PAVING & DIMENSIONAL CONTROL PLAN						
WESTERN INTERNATIONAL OFFICE BUILDING						
WESTERN INTERNATIONAL						
MAYSE & ASSOCIATES INC.						
TOWN OF ADDISON, TEXAS						
DESIGN	DRAWN	DATE	SCALE	XREF	FILE	NO.
RLG	RLG	10/16/18	1"=20'	1813.013	1813	013
JOB NO. 1813.013		SUBMITTAL:

WESTERN INTERNATIONAL OFFICE BUILDING
 15275 QUORUM DR.
 ADDISON, TX 75001

STORM SEWER PLAN						
WESTERN INTERNATIONAL OFFICE BUILDING						
WESTERN INTERNATIONAL						
MAYSE & ASSOCIATES INC.						
TOWN OF ADDISON, TEXAS						
DESIGN	DRAWN	DATE	SCALE	XREF	FILE	NO.
RLG	RLG	9/27/18	1"=20'	1813.013	1813	013
JOB NO.	SUBMITTAL:					
1813.013

UTILITY PLAN & PROFILES						
WESTERN INTERNATIONAL OFFICE BUILDING						
WESTERN INTERNATIONAL						
MAYSE & ASSOCIATES INC.						
TOWN OF ADDISON, TEXAS						
DESIGN	DRAWN	DATE	SCALE	XREF	FILE	NO.
RLG	RLG	10/16/18	1"=20'	1813.013	1813	013
JOB NO. 1813.013		SUBMITTAL:

SHEET NO.
C5.00

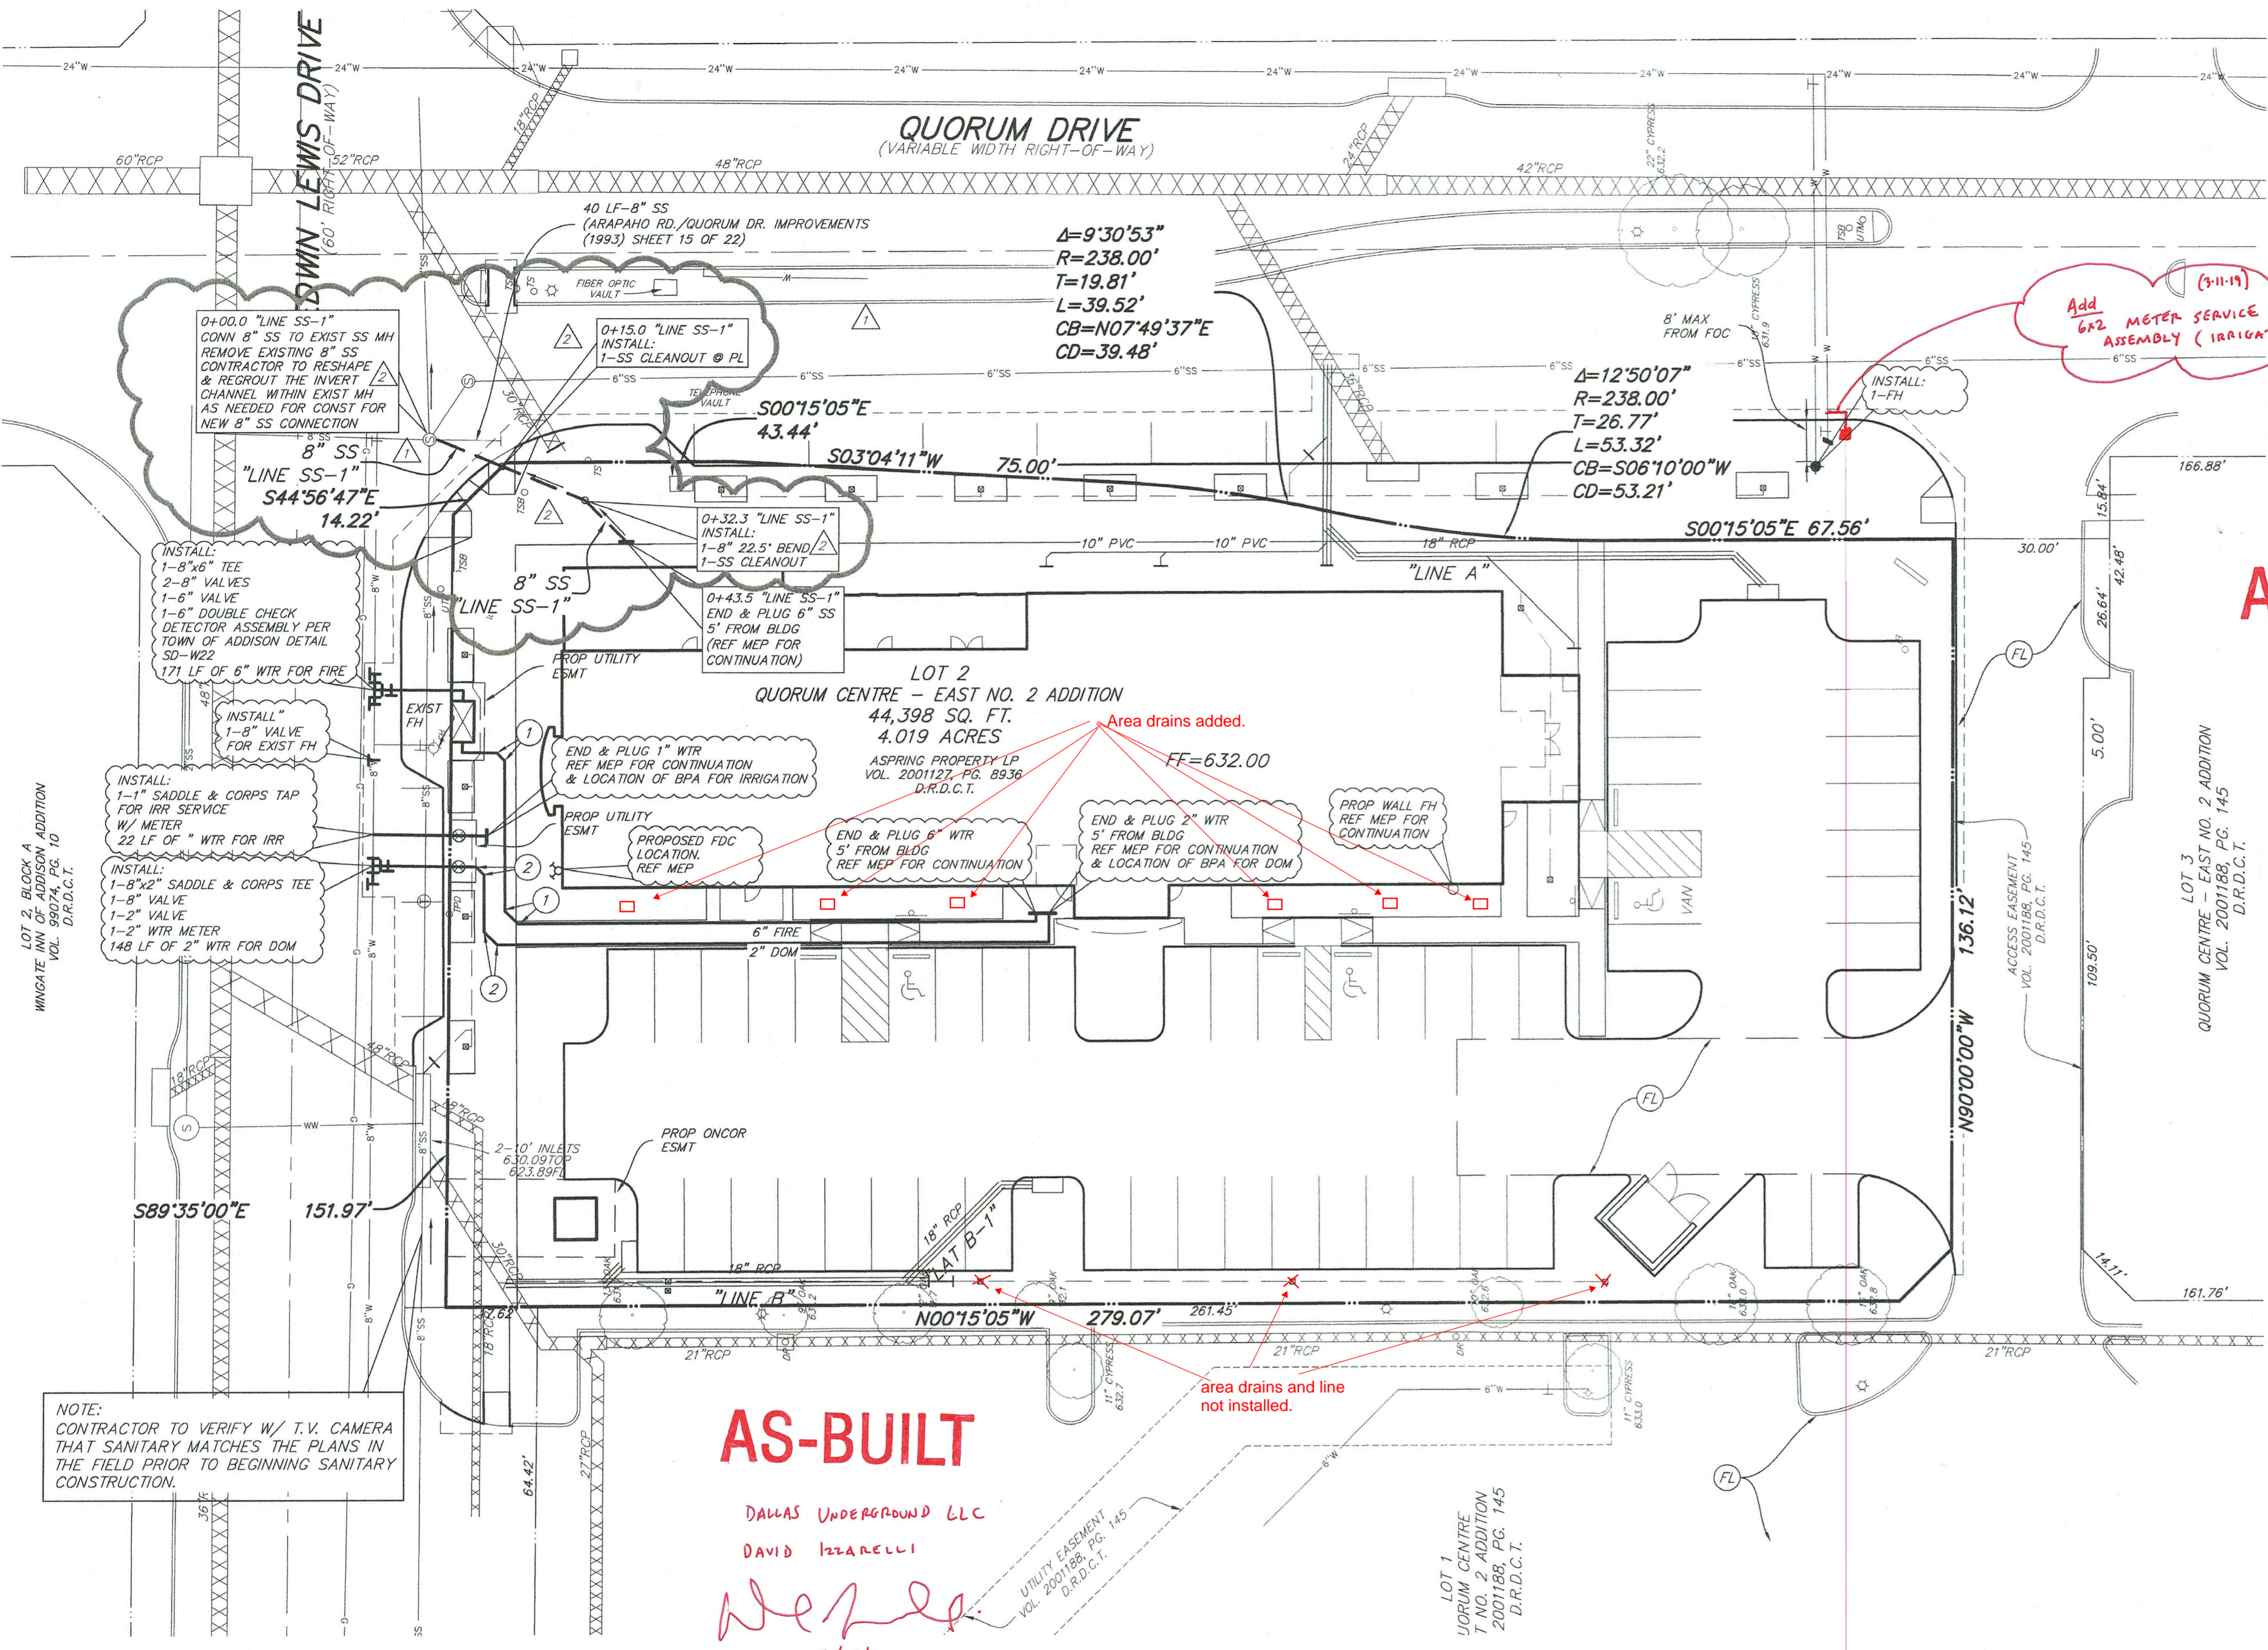
Slot drain added into concrete for drainage.

Add
 - 80 LF 8" HDPE
 - 10x8 REVDLER
 - 8" CAP
